TECHNICAL BULLETIN

Product: HDK-79E, HDK-79D, and HDK-725P cameras (also studio models)

Purpose: To ensure compatibility with SHED HDX by changing the capacitor to a bi-polar type.

Figure 1 – P/S & Audio board

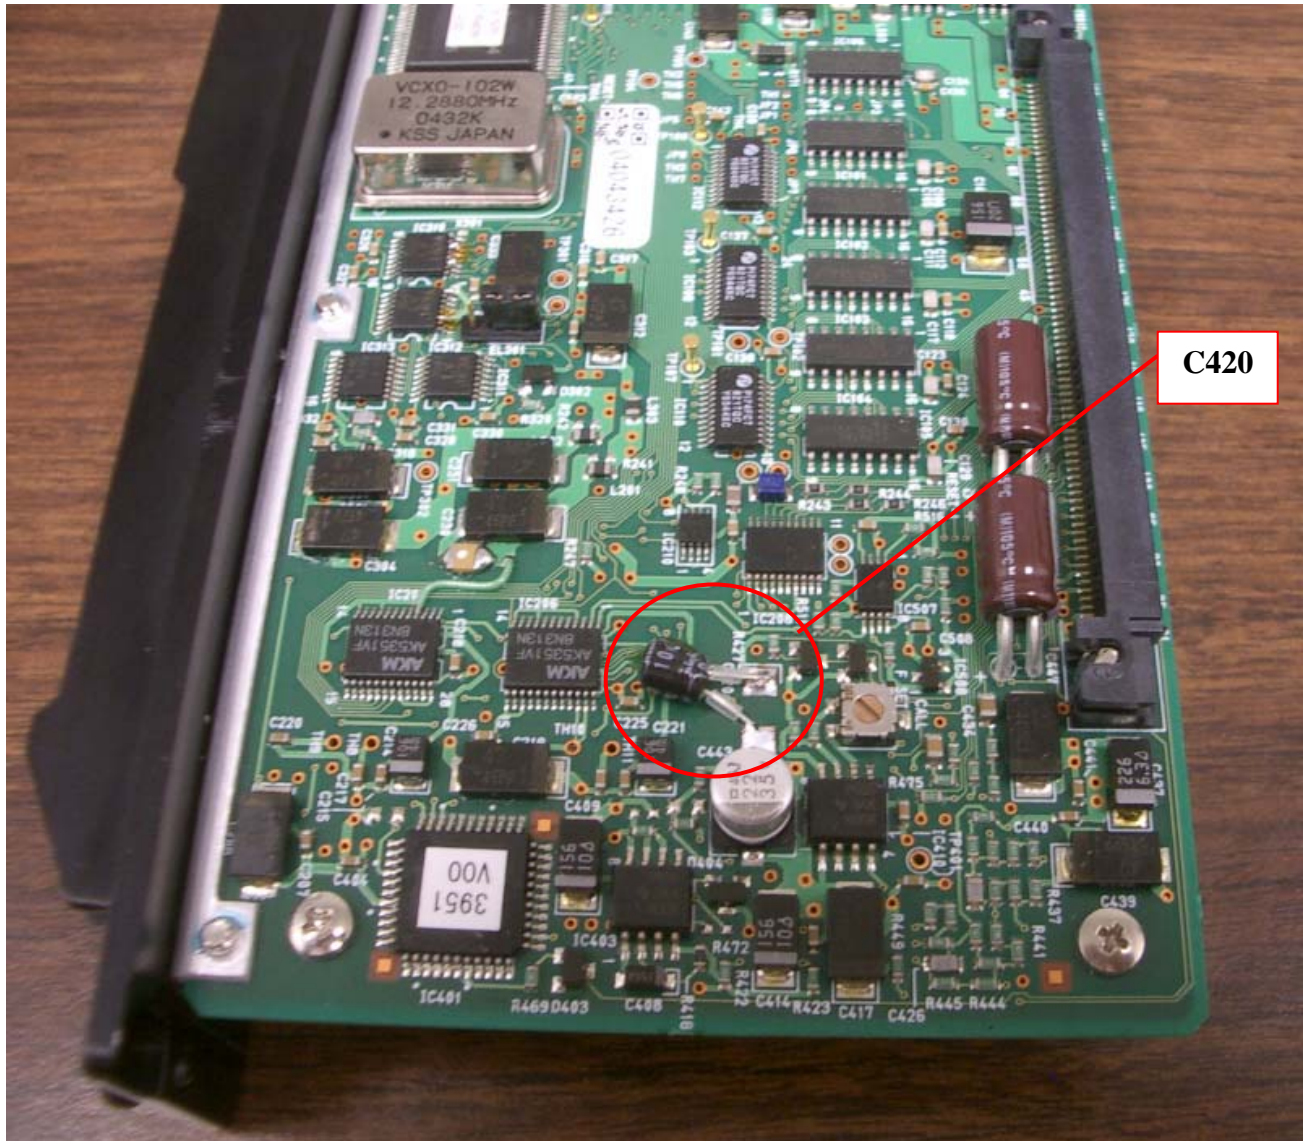
Symptom: When the camera is connected to a Telecast SHED HDX the 1K load of the HDX causes a capacitor on the P/S & Audio board to be reverse biased, which causes the voltage on the camera to CCU low voltage sense line to increase over time, sometimes exceeding the HDX detection range for an Ikegami type camera. The HDX may then shut down or power cycle. This capacitor will become damaged over time, further increasing the likelihood of voltage detection errors in the HDX.

Instruction: Remove the P/S & Audio board from the FA Fiber Adapter. Remove capacitor C420 (15uF/10v) and replace with a 10uF/10v bi-polar capacitor, part number UMP1A100MDD. Since the bi-polar replacement capacitor is not surface mount type, it should be mounted on its side using a silicone adhesive to maintain position. Refer to figure 1 for part location.
